Naval Research Laboratory

NRL/MR/7441--94-7541

Digital Mapping, Charting, and Geodesy Analysis Program Technical Review of Vector Quantization (VQ) Decompression for the National Imagery Transmission Format Standard (NITFS)

Figure 1. RPF frame file structure taken from [4] (cont'd).

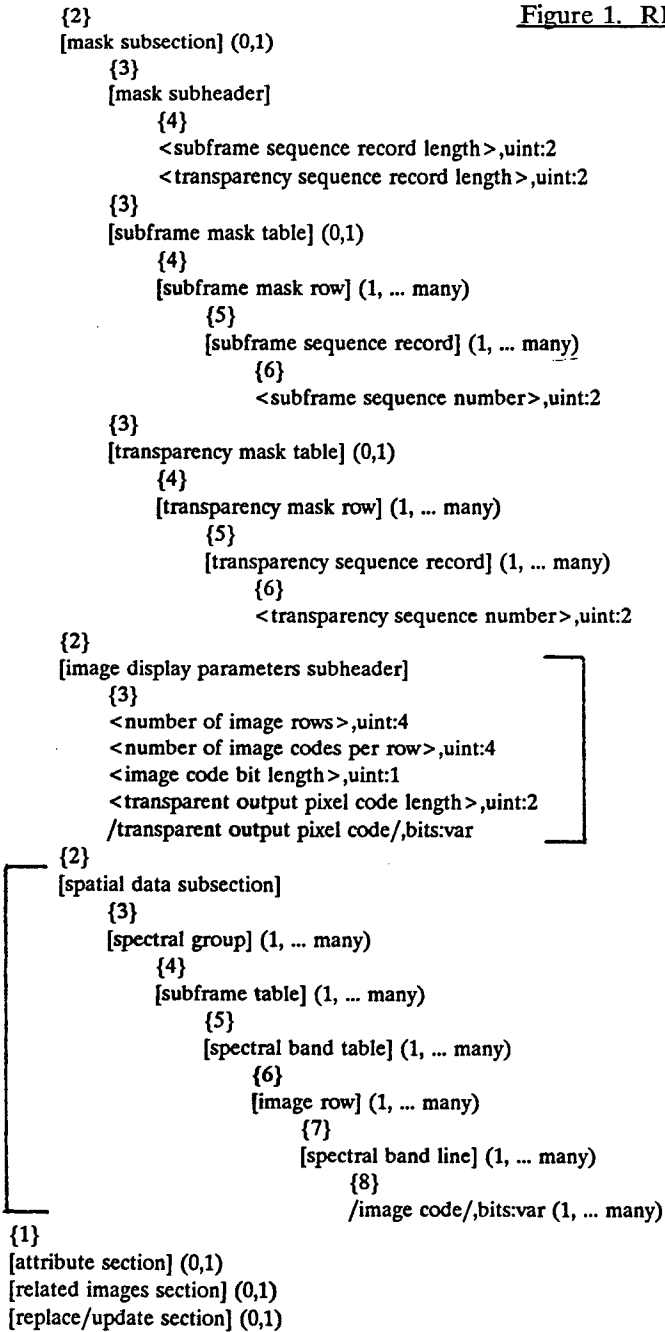
Moreover, VQ images could not be easily read by RPF compliant software, even though that *same* image formatted in the RPF could be read. This fact is evidenced by Figures 1 to 4, where similar sections between the figures are marked for easy association. Figure 1 details an RPF frame file and Figure 2 shows the VQ file structure. Although both are similar to the NITF (Figures 3 and 4), obvious differences exist. DMAP recommends the following additions/changes to the VQ standard's [NITF image] (Figure 7 on page 13 of [2]) for at least minimal agreement with the RPF's [frame file]:

These figures also show some minor differences that, once changed, could make the parallel sections correspond more closely. For instance, in Figure 1, the name [*subframe* table] is used at a structural level where the name [*block* table] appears in figure 2. Do these names and locations imply that a *subframe* in RPF corresponds to a *block* in a VQ image? If so, then the correspondence should be clarified in the RPF or VQ standard.

- i. Add a tagged [color/grayscale section] to the image subheader;
- ii. Add a [compression parameters section] to house the [image display parameter subheader];

- iii. Increase the [compression section] to level {2}. Note: in the RPF [frame file], the [compression section] is on the same level as [image section].

Figure 4. NITF file structure taken from [1].

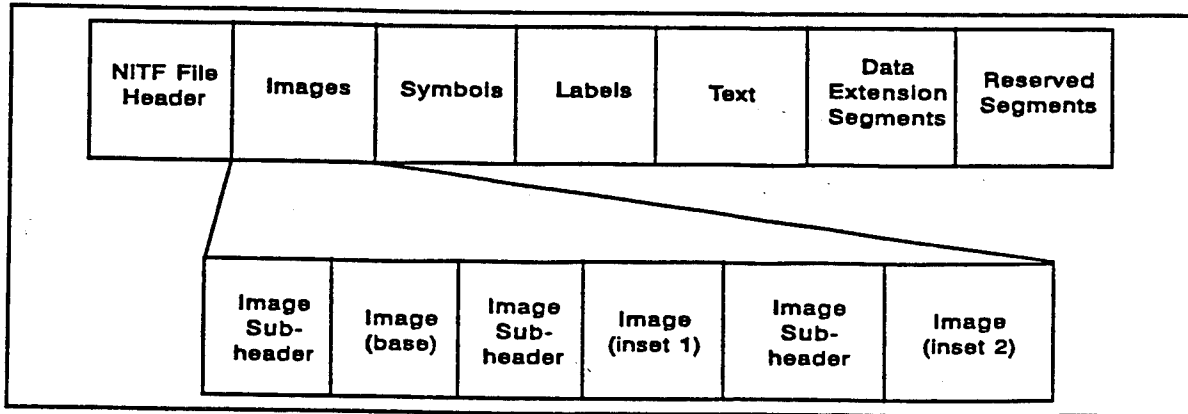
20. P 6 F 2 For completeness, this figure should include (but not emphasize) the information in figure 4 of this review, which shows other NITF sections such as the symbol section and label section.
